<b>Subject:</b>  EXHAUST LEAK NOISE FROM REAR OF VEHICLE	<b>Bulletin No:</b> 01-025/12
	<b>Last Issued:</b> 11/16/2012

2009-2012 Mazda6 vehicles produced before June 7, 2012

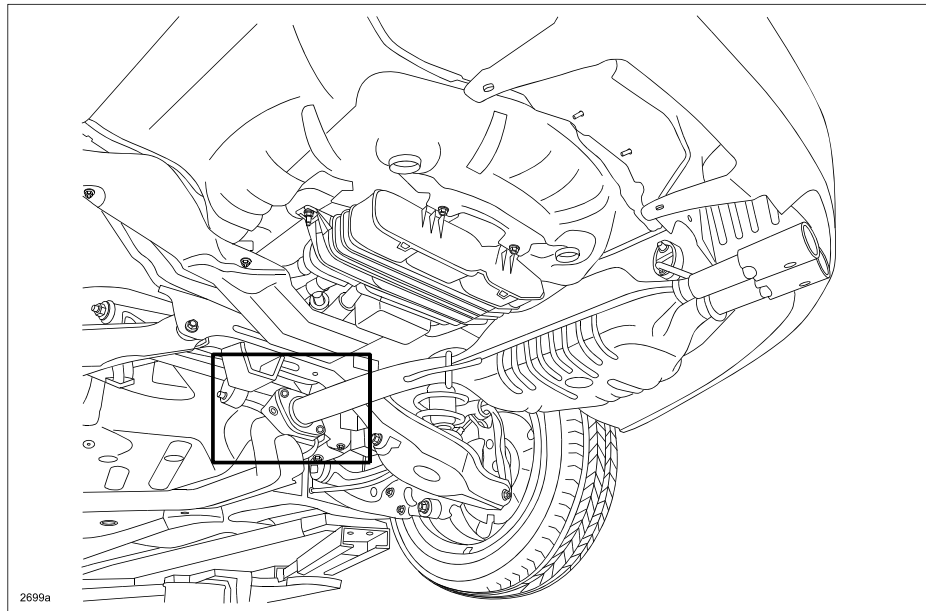
Some vehicles may exhibit an exhaust leaking noise from the rear of the vehicle. The noise may be caused by a gap between the exhaust hanger bracket and flange, which allows moisture to enter and cause the exhaust studs to rust and possibly break off.

The welding location of the exhaust hanger bracket and flange has been changed to ensure the hanger bracket and flange are flush with no gaps to allow moisture intrusion.
